Würth Elektronik eiSos GmbH &amp; Co. KG

## Product / Process Change Notification (PCN)

**PCN #:** PCN\_WL-SMSW\_3014\_20220226

**Affected Series:** 155301xx73100

## Product dimensions after change

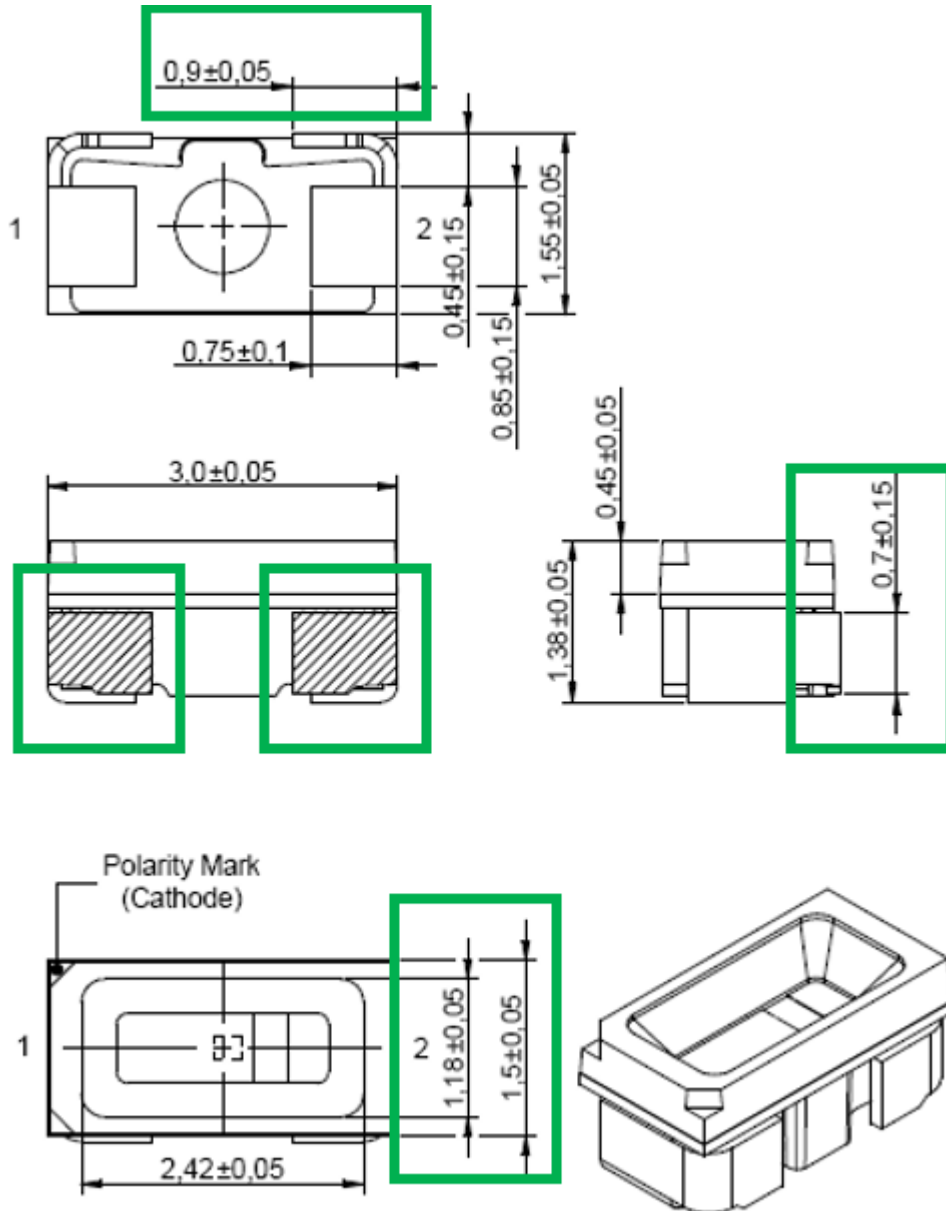
The marked soldering areas are corrected on the side view of the LED instead of bottom view. The main changed values of the new design are marked green. The other dimension values are also varied according to this change

## Recommended land pattern

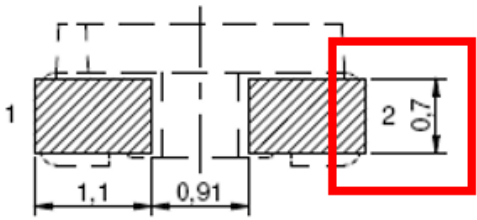
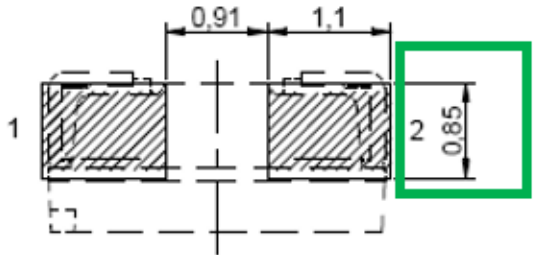
The updated contact pads are still passed on the old recommended land pattern design

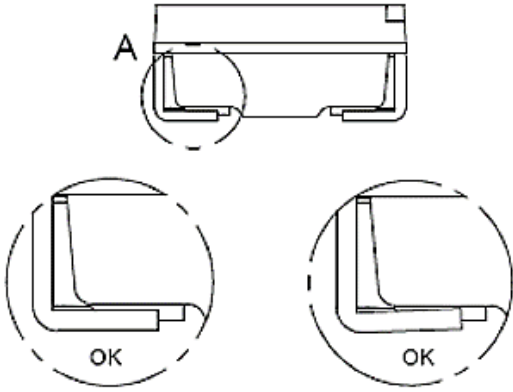
Instead of showing the schematic of LED, the detail A of lead frame is revised
